[Docket No. NHTSA-99-5572; Notice 3]

Federal Motor Vehicle Safety Standards; Roof Crush Resistance

ACTION: Final rule.

Figure 1. Test Device Orientation

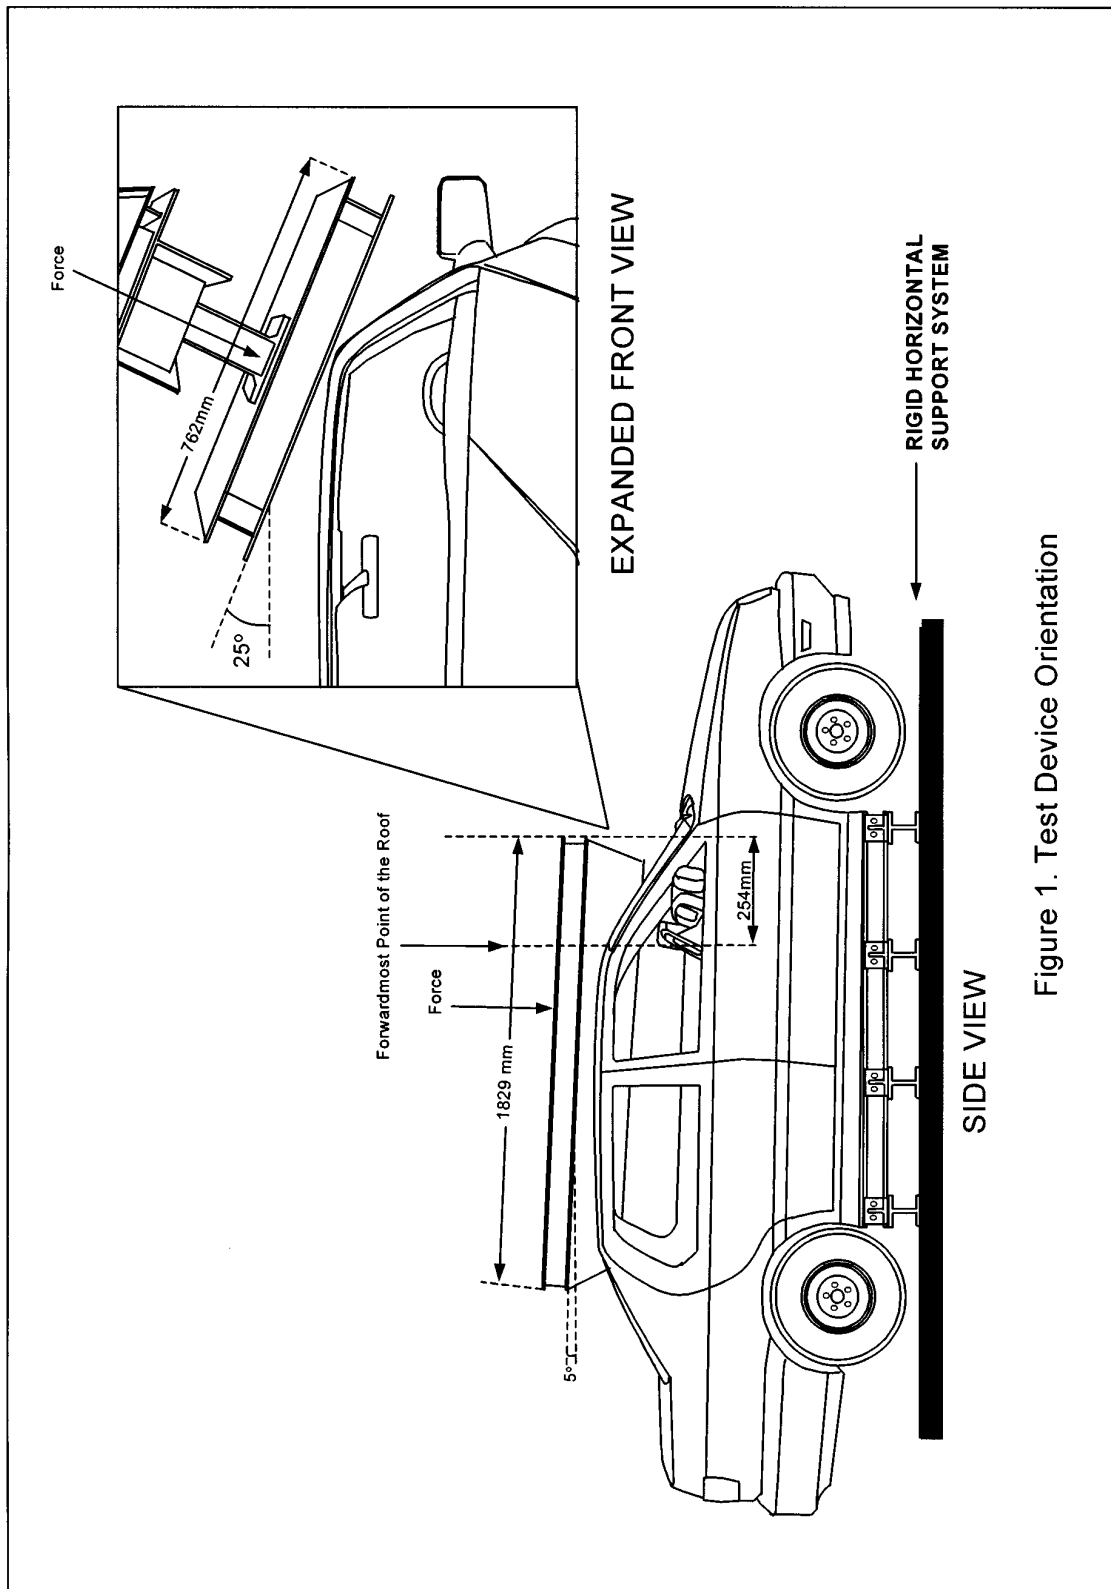
Paragraph S7.2 has been rewritten to clarify, but not change, the process of orienting the test plate and lowering so that it makes initial contact with the vehicle being tested. In addition, the agency is making a number of clarifying minor changes to the regulatory text. In particular, a sentence was added to the test procedures to explicitly specify that non-structural components such as roof racks are removed prior to testing. This was already the agency's interpretation of the current test procedure. The word "accidents" in S2 is replaced with the word "crashes." Figure 1 is revised to

- a. S2 is revised.
- b. S4 is revised.
- c. S5 is revised.
- d. S6 is revised, and S6.1, S6.2, 6.3 and S6.4 are removed.
- e. S7, S7.1, S7.2, S7.3, S7.4, S7.5, and S7.6 are added.
- f. A heading is added preceding Figure 1 at the end of the section and Figure 1 is revised.

S7.2 Orient the test device as shown in Figure 1 of this section, so that—

(a) Its longitudinal axis is at a forward angle (in side view) of 5 degrees below the horizontal, and is parallel to the vertical plane through the vehicle's longitudinal centerline;

(2) Except as specified in S7.4, the midpoint of the forward edge of the lower surface of the test device is within 10 mm of the transverse vertical plane 254 mm forward of the forwardmost point on the exterior surface of the roof, including windshield trim, that lies in the longitudinal vertical plane passing through the vehicle's longitudinal centerline.

S7.4 If the vehicle being tested is a multipurpose passenger vehicle, truck, or bus that has a raised roof or altered roof, and the initial contact point of the test device is on the raised roof or altered roof to the rear of the roof over the front seat area, the plate is positioned so that the midpoint of the rearward edge of the lower surface of the test device is within 10 mm of the transverse vertical plane located at the rear of the roof over the front seat area.
